Submissions from Public Authorities - Natural Resources Access Regulator (NRAR)

**Re: Planning Proposal PP054 - Rezoning of Riparian Land at Lot 1 DP 949932, Taylors Lane, Cambewarra**

**Planning Proposal PP054 - Rezoning of Riparian Land at Lot 1 DP 949932,  
Taylors Lane, Cambewarra**

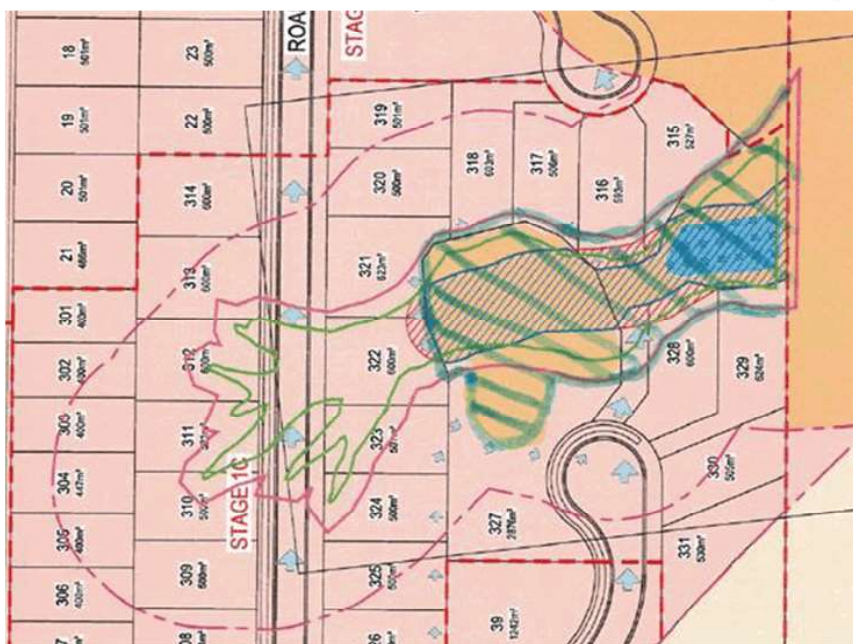
Thanks again for your additional comments. Can you advise if NRAR would be supportive of a revised proposal based on the draft mark-up attached (and shown below)?

It shows a revised riparian corridor (proposed E2 zone) in green hatching, with the western extent of the corridor located at the trees proposed to be retained, and incorporating a 5m buffer measured from the 'bank' (blue line) shown in Figure 6 of the Niche study.

Seems fine and establishes a more uniform width corridor.

For on-ground practical purposes can I just suggest that you apply a "smooth" edge to the zone boundary. Not one that goes around individual trees with little indentations.

Figure 4: Recommended riparian extent (Niche Environment & Heritage, 2020)

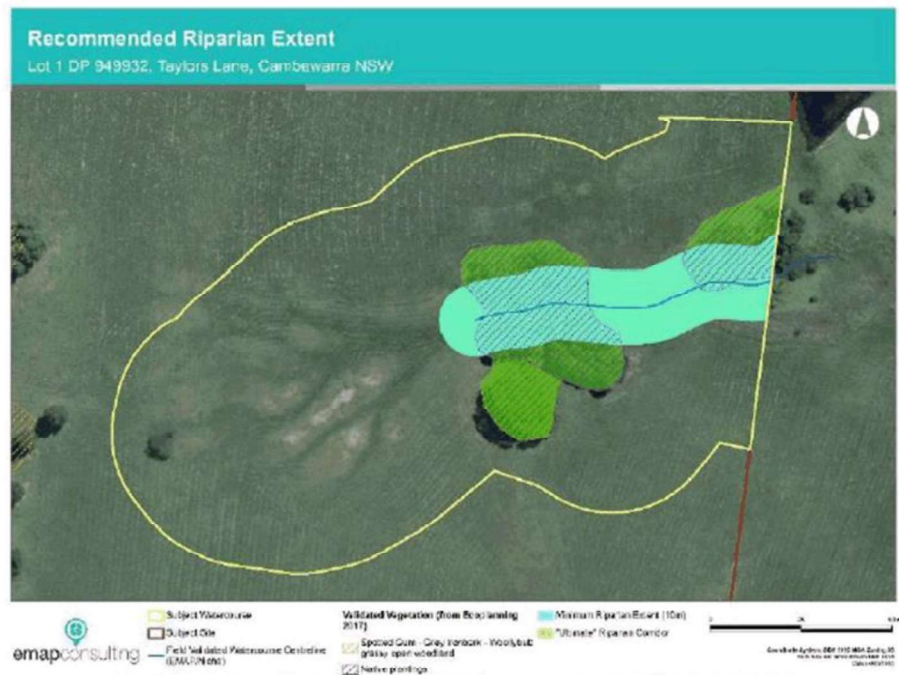
I refer to the application to change much of the land zoned E2 to Residential R1 and reduce considerably that which was zoned E2. Shoalhaven Water does not object to the planning proposal to change much of the E2 zone land to R1.

It is noted that the reduction of the land zoned E2 may cause the need to consider alternative sewer servicing option/s (eg, pressure sewer) as the land closer to the centreline of the water course is more likely to more often have ground water and hence impact on a gravity sewer system by way of infiltration.
